WC98-2204 - FIDUCIARY TRUST INT'L.

2 WTC 95-96 FL

RE: FIDUCIARY TRUST INTERNATIONAL - 2 WTC - 95th & 96th FLOORS
TAA 982204 - SELF CERTIFICATION
REVIEW COMMENTS

**ATTACHMENT B - LIST OF DRAWINGS
2 WTC 95th & 96th FLOORS
FIDUCIARY TRUST INTERNATIONAL
TAA 982204
SELF CERTIFICATION – REVIEW COMMENTS**

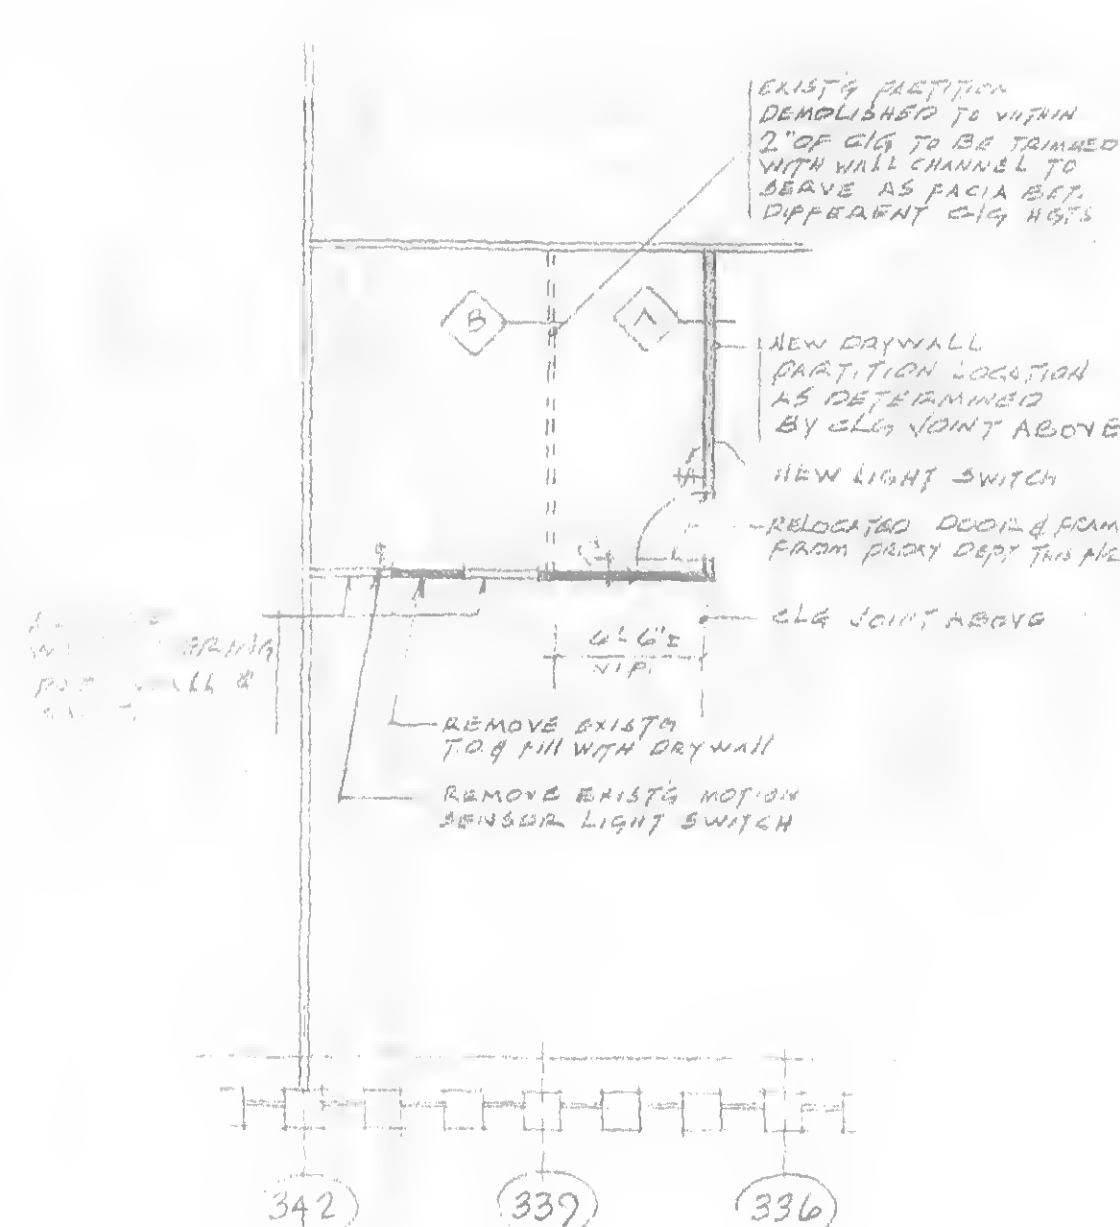
1. Drawing A-1. Verify removal of light switch with motion sensor is local only and not part of a floor wide motion sensing system.
